Regulation No. 46 (Devices for indirect vision)

Proposal for 04 series of amendments to Regulation No. 46

Submitted by the expert from the Netherlands*

Figure 7:

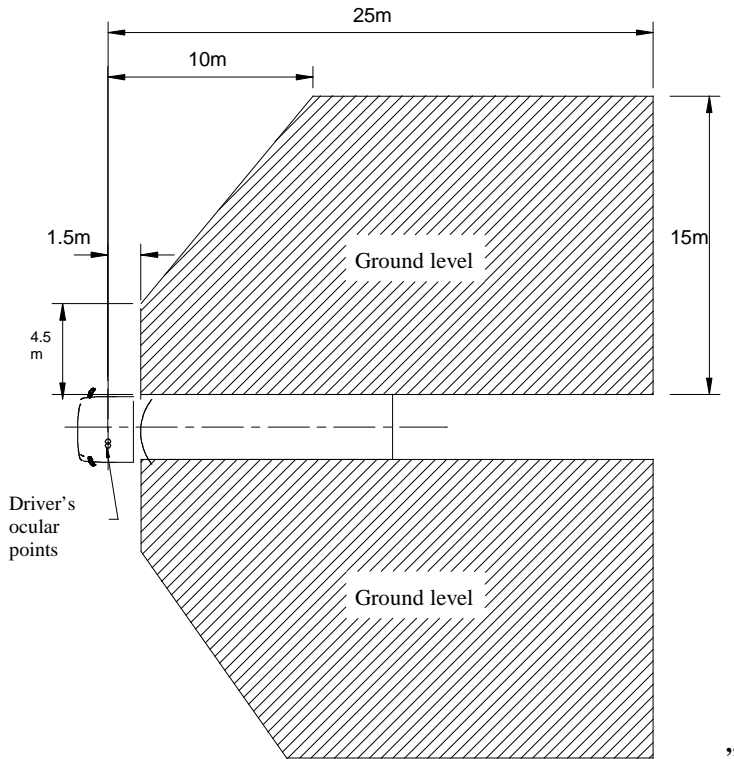
~~Field of vision of Class IV wide-angle mirrors~~ **Class IV wide-angle field of vision**

33. Alignment of the text with the new definition of classes (paragraph. 2.4). Figure 7 has been corrected on the passenger's side so that the indicated dimensions are in correspondence with the front of the grey area.
